# Technical Bulletin

## Tension setting procedure for PSA 1.9 D engines

<b>GATES REFERENCE :</b>	<b>5523XS/K015523XS/KP15523XS</b>
<b>MAKE :</b>	CITROEN, FIAT, PEUGEOT, TOYOTA
<b>MODEL :</b>	Various
<b>ENGINE :</b>	1.9 D
<b>ENGINE CODE :</b>	DW8, DW8B, WJZ, 1WZ

Fig. 2

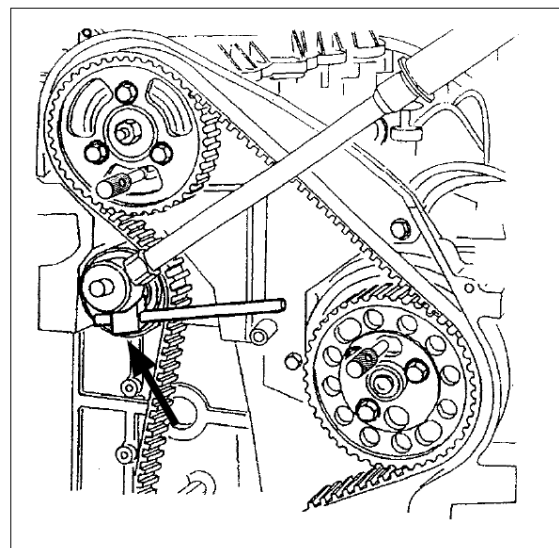
- This tool is needed in order to turn the tensioner and hold it in place while tightening the locking bolt (25 Nm)(Fig. 2).

Fig. 3

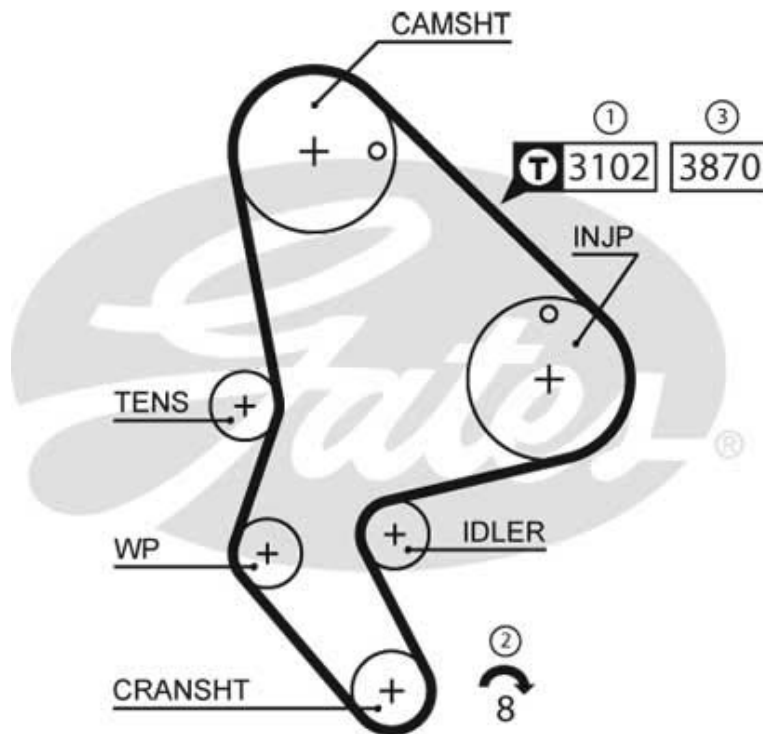
- ① - Initially, the belt has to be installed at a higher than normal tension (pretension).  
The tension is measured with a Gates STT-1 tension tester in the span between the camshaft and the injection pump. Enter code 3102
- ② - The crankshaft pulley is then rotated 8 revolutions, clockwise
- ③ - The tension is then adjusted to the final level, and the value is again confirmed with the STT-1 tension tester. Enter code 3870

The procedure will be visualised on the PowerGrip® Kit and belt box label as in Fig 3.
